MFN 10-089 Revision 1

Subject: **Revised Response to NRC RAI Letter No. 409 Related to ESBWR Design Certification Application – DCD Tier 2 Section 10.2 – Steam and Power Conversion System; RAI Number 10.2-18 S03**

DCD Tier 2 Section 10.2 – Steam and Power Conversion System

RAI Number 10.2-18 S03

Figure 10.2-1. Turbine Stop Valve Closure Characteristic

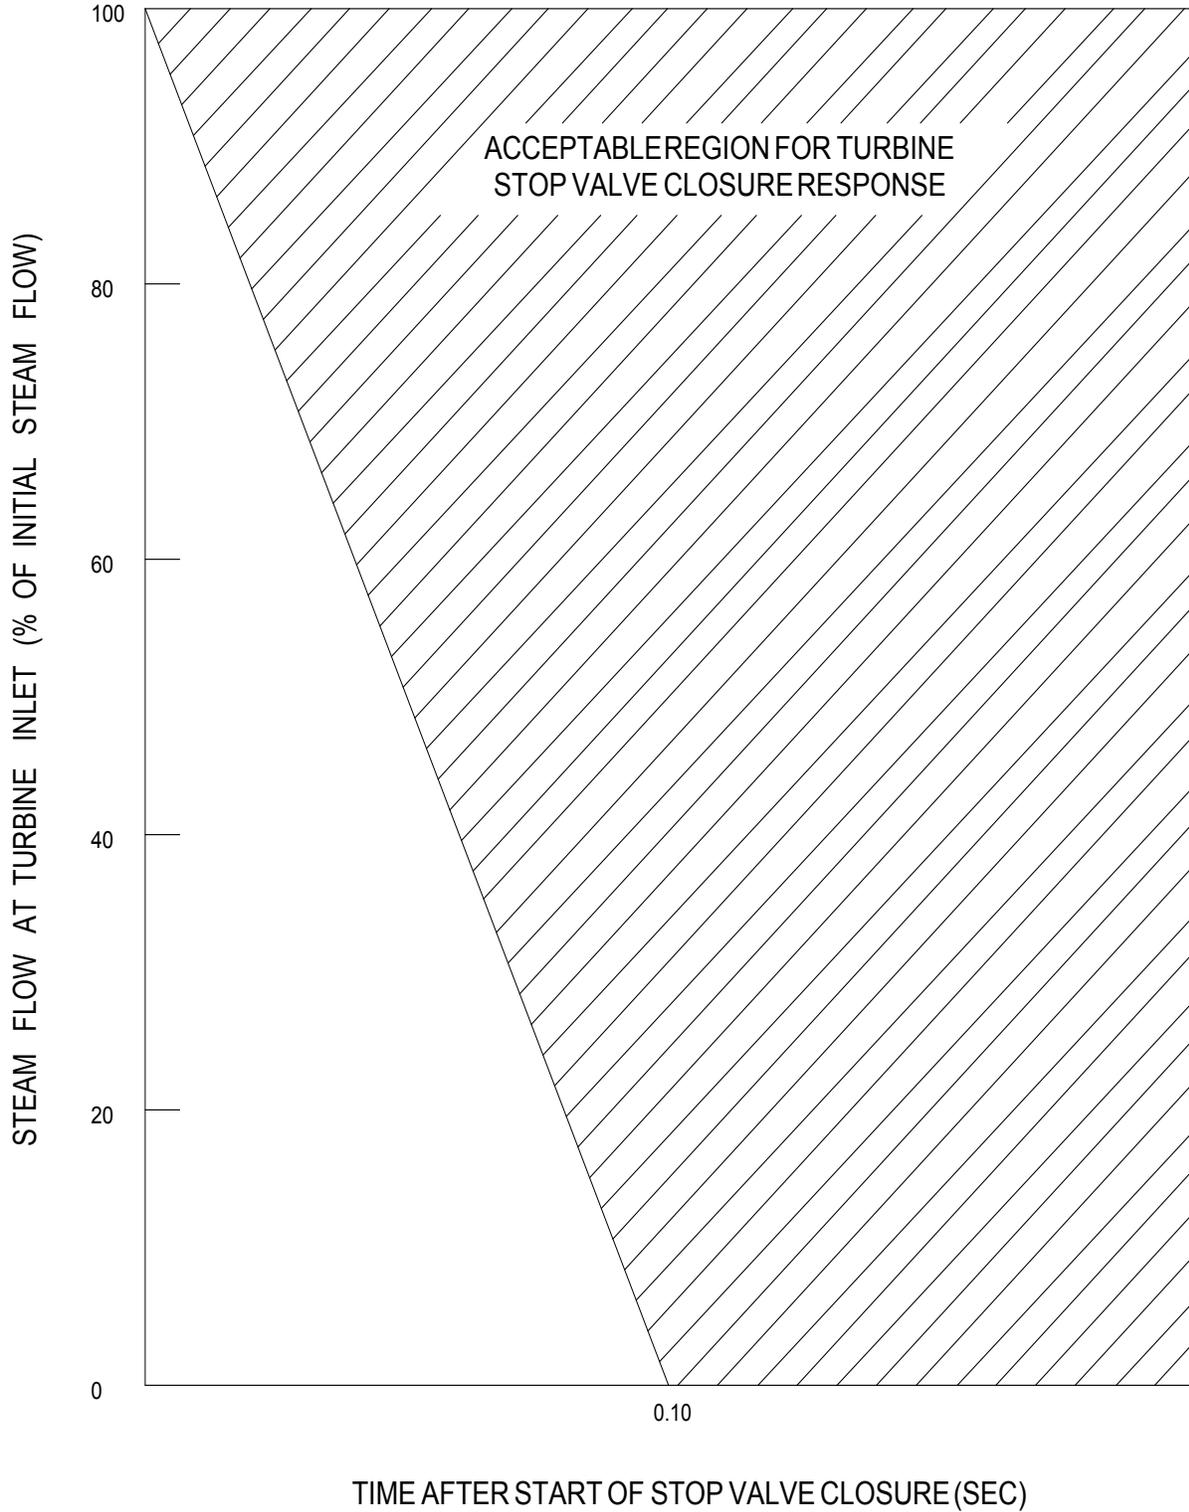
6) The bases for the times shown in Figures 10.2-1, 10.2-2, and 10.2-3 are not explained **[the distinction between Figures 10.2-2 and 10.2-3 has not been adequately addressed in the proposed DCD markup]**; and T_v is not defined on Figure 10.2-3.

- 6) *The bases for the times shown in Figures 10.2-1, 10.2-2, and 10.2-3 are not explained [the distinction between Figures 10.2-2 and 10.2-3 has not been adequately addressed in the proposed DCD markup]; and T_v is not defined on Figure 10.2-3.*

During an event resulting in turbine stop valve fast closure, turbine inlet steam flow is not reduced faster than that shown in Figure 10.2-1 [to comply with the transient analyses in DCD Chapter 15.](#)

Figure 10.2-2. Turbine Control Valve Fast Closure Characteristic

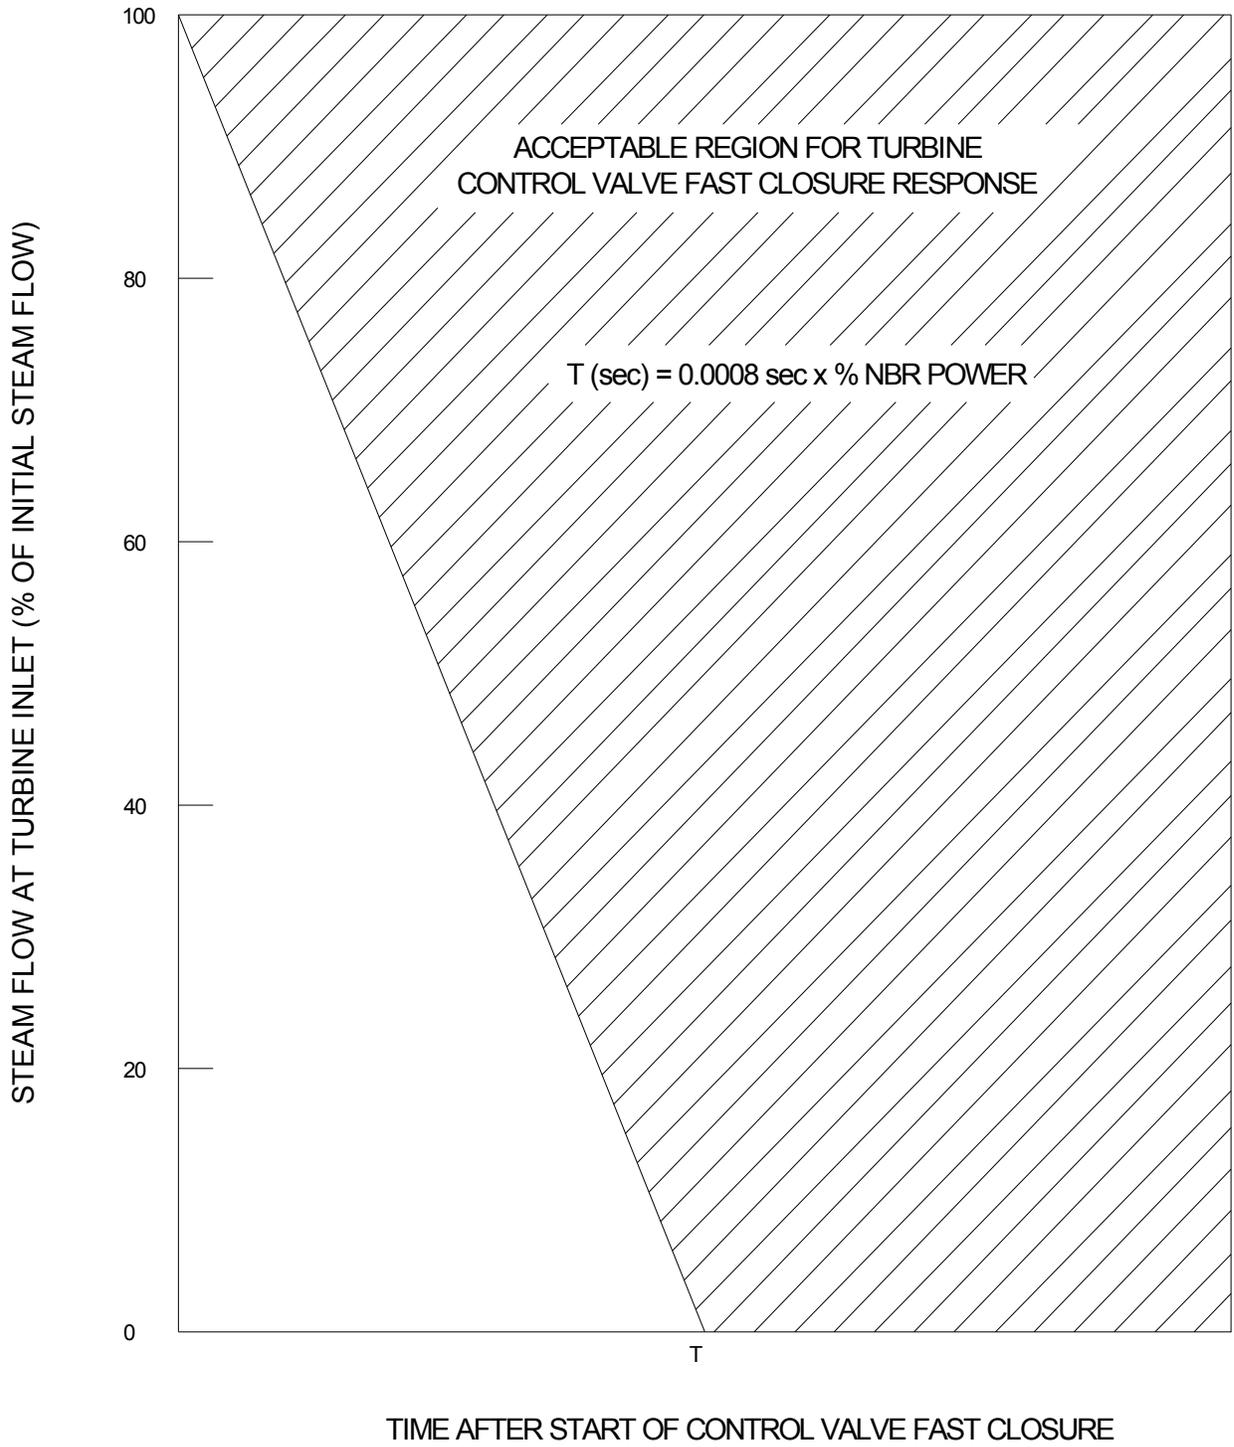
Section 10.2.1.3.2: First sentence, include the reason for the times shown in Figure 10.2-2 (e.g., to comply with transient requirements).

During any event resulting in turbine control valve fast closure, the turbine inlet steam flow is not reduced faster than that shown in Figure 10.2-2 to comply with the transient requirements.

During any event resulting in turbine control valve fast closure, the turbine inlet steam flow is not reduced faster than that shown in Figure 10.2-2 [to comply with the transient analyses in DCD Chapter 15.](#)

Figure 10.4-6a. Low Pressure Extraction Steam System

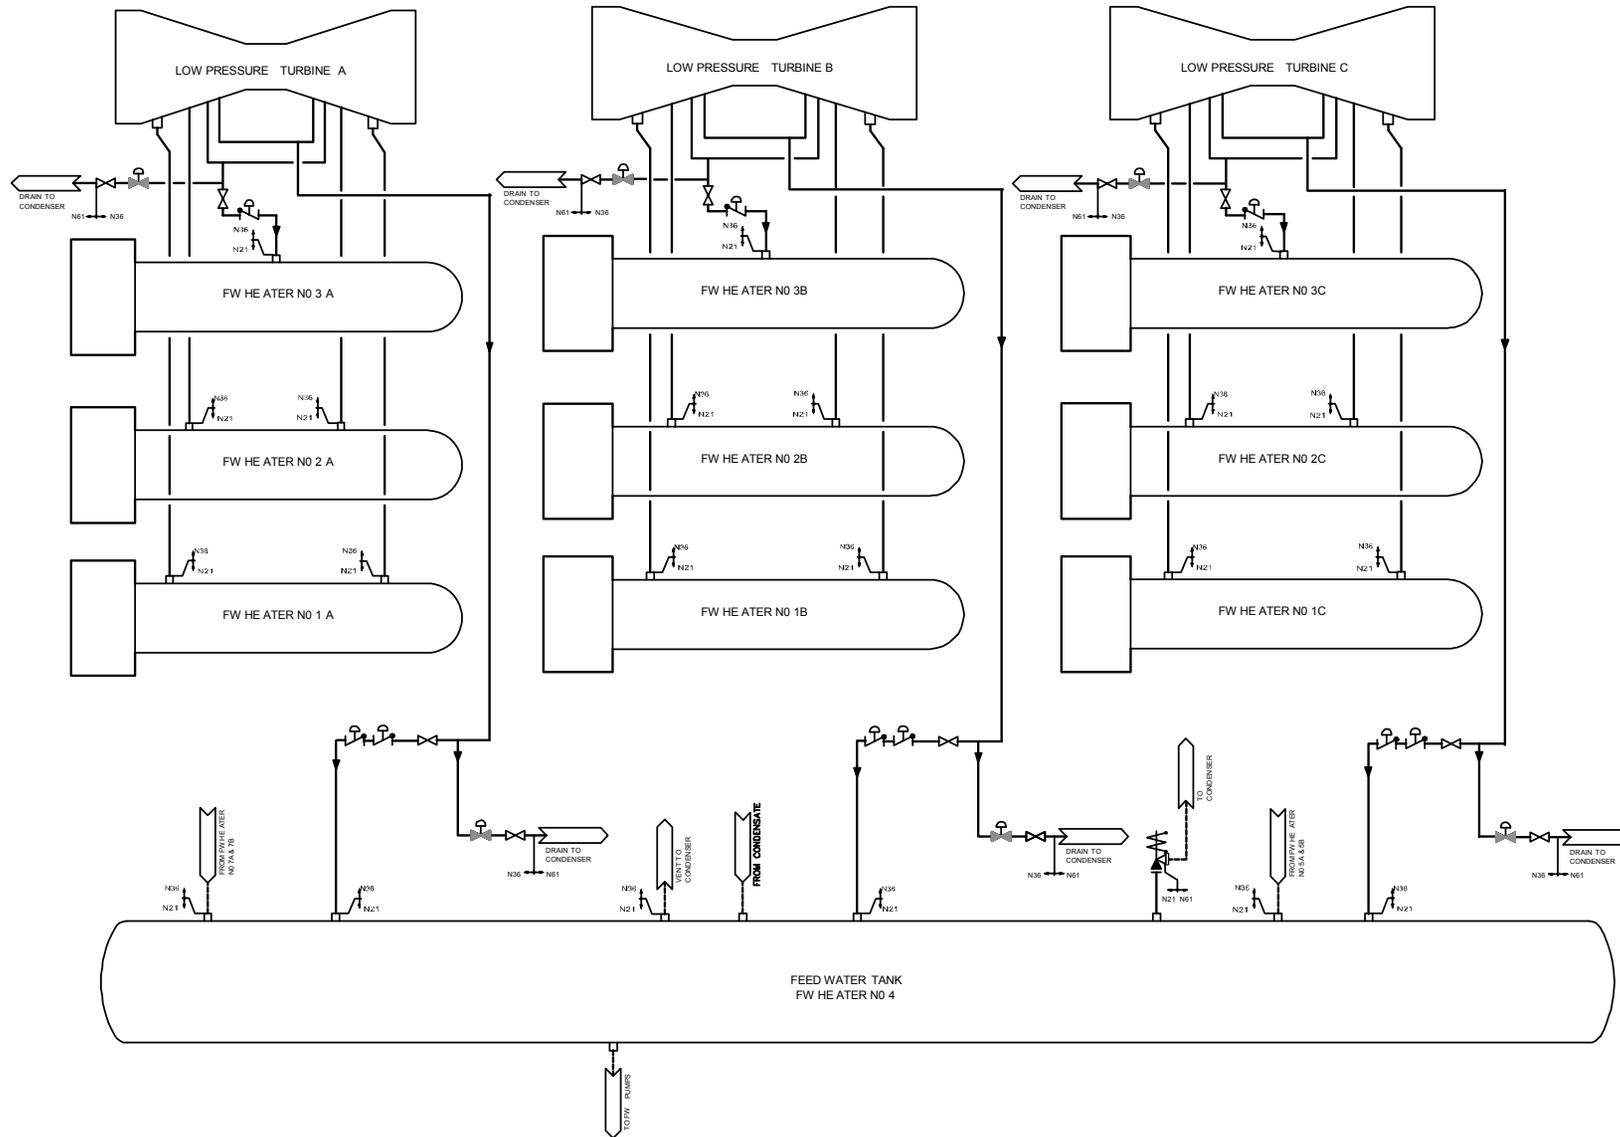
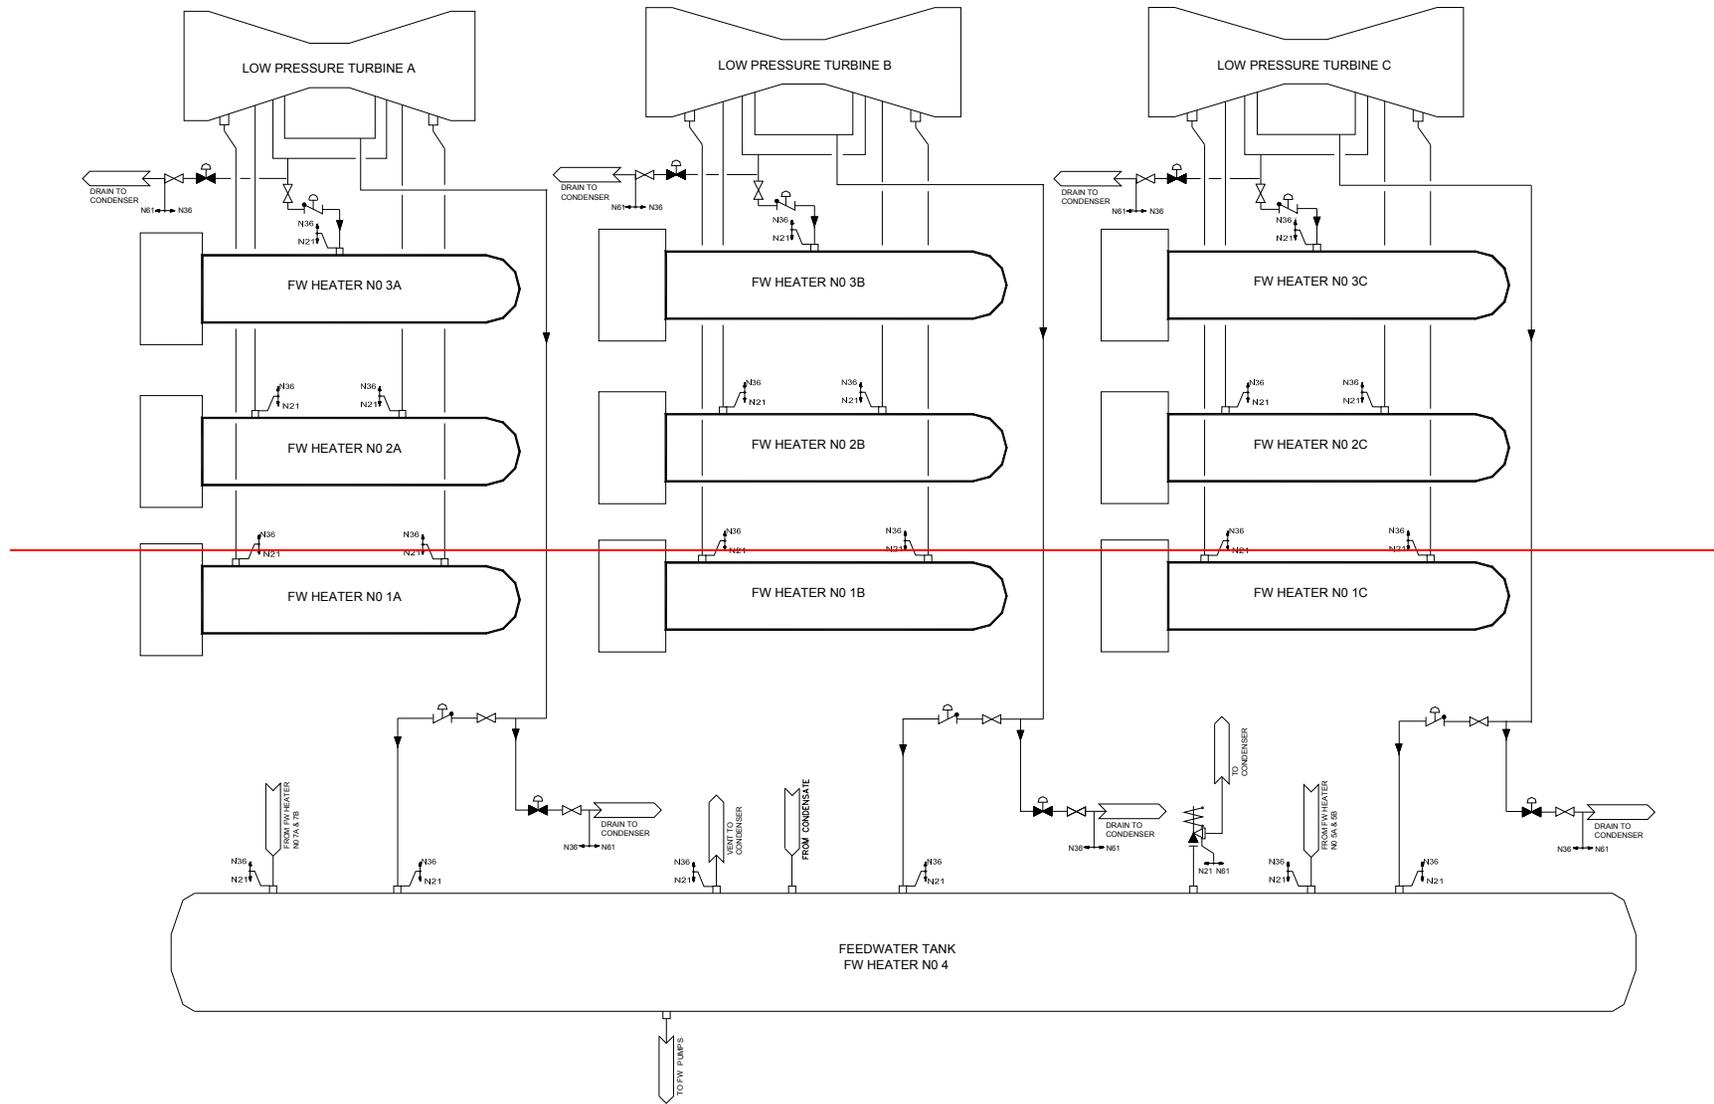
GEH has provided inconsistent information concerning where non-return valves are located and to what extent they are needed in order to prevent the turbine from exceeding 120% rated speed, including consideration of single failures. [NRC] current understanding based on the most recent information that was provided is that both power assisted and simple non-return check valves need to be credited to prevent the turbine from exceeding 120% rated speed during a loss of load event. The proposed revision in the February 28 e-mail response provides an acceptable description. However, the Tier 1 functional diagram needs to be revised to include simple non-return check valves that are needed to prevent the turbine from exceeding 120% rated speed.

DCD Figure 10.4-6a has been revised to correct the quantity of non-return valves required for the number four (4) open feedwater heater. This is also discussed in DCD Subsection 10.2.2.2.6.

The proposed DCD Subsection 10.2.2.2.6 and Figure 10.4-6a shows the location and quantity of spring assisted extraction steam non-return valves that are required on the
